To: T10 Technical Committee
From: Rob Elliott, HP (elliott@hp.com)
Date: 6 December 2007
Subject: 08-011r0 SAS-2 XL Forward Dword correction

Overview

Figure 2 — XL (link layer for expander logical phys) state machine (part 2) **[modified]**

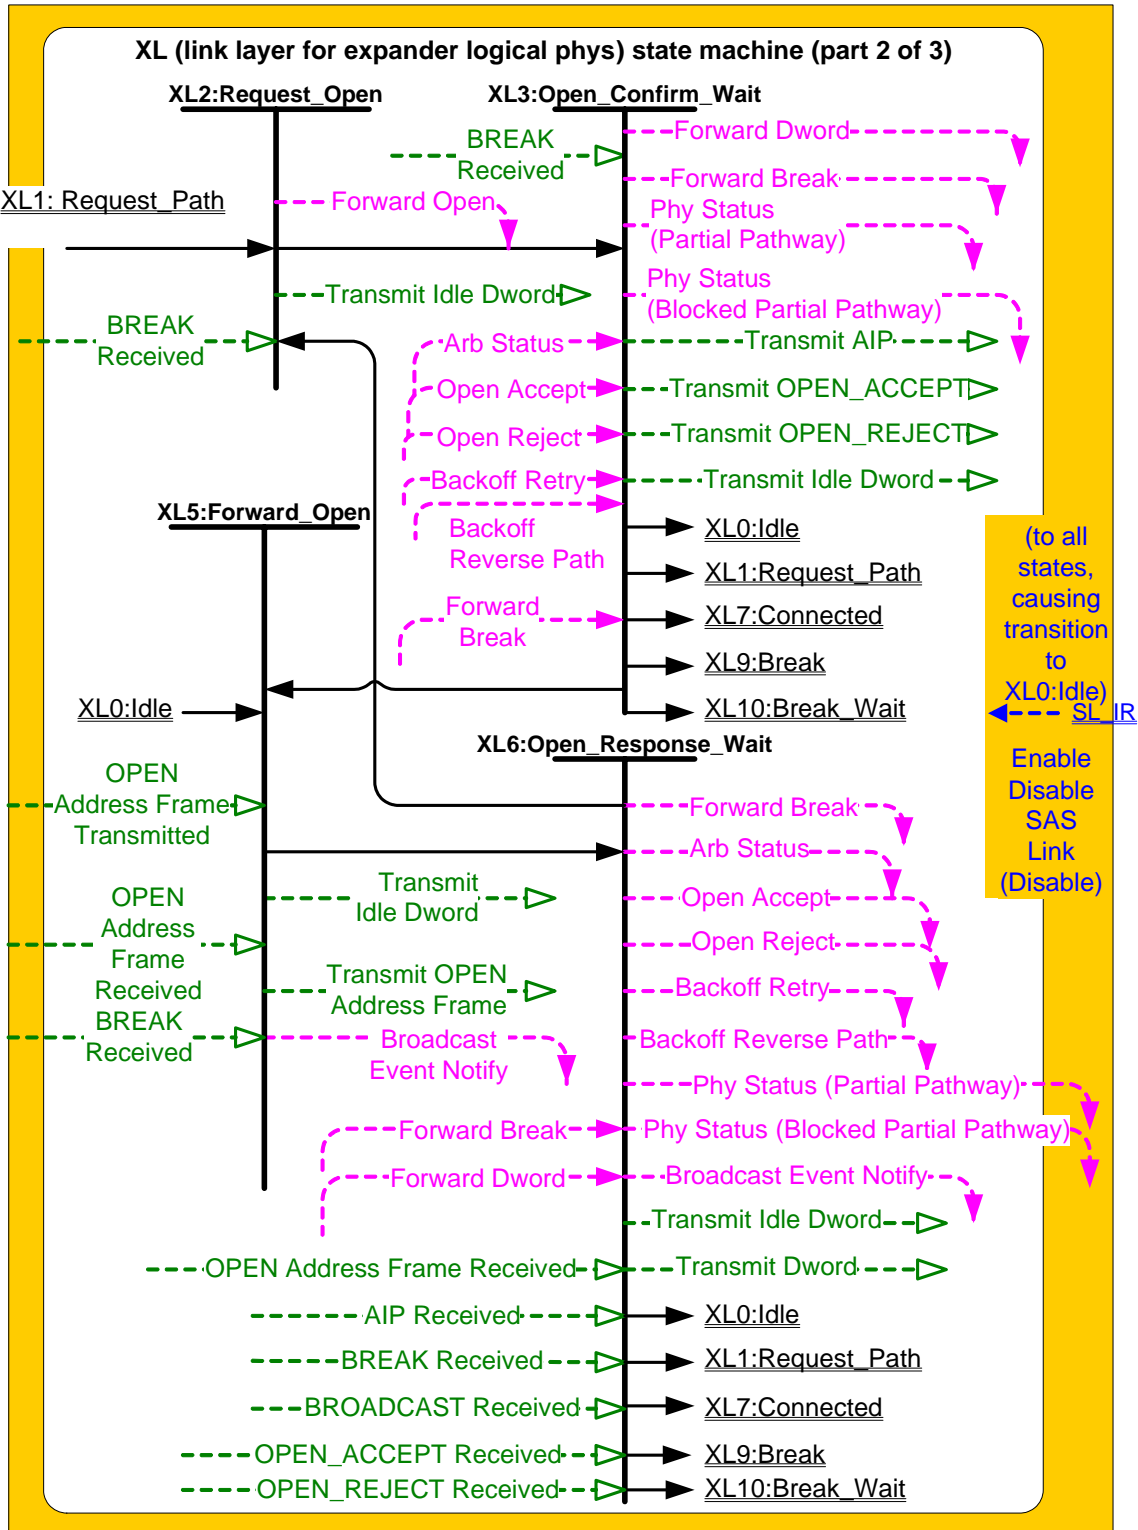
In the XL state machine, the XL3:Open_Confirm_Wait state (which is entered after sending an OPEN to the ECR; the state waits for a reply) is supposed to send a Forward Dword request to the ECR for each dword received on the phy. This is already reflected in all the example figures in annex J and the fact that the XL6 state (in the other expander phy) is prepared to receive Forward Dword indications.

As noted by Tim Hogleund (LSI), a statement about expanding and collapsing STP primitive sequences in XL6 is not applicable, as only idle dwords are flowing at that time; this statement is deleted.

If a Dword Received message is received containing a valid dword except a BREAK primitive, this state shall send a Forward Dword request to the ECR containing that dword.
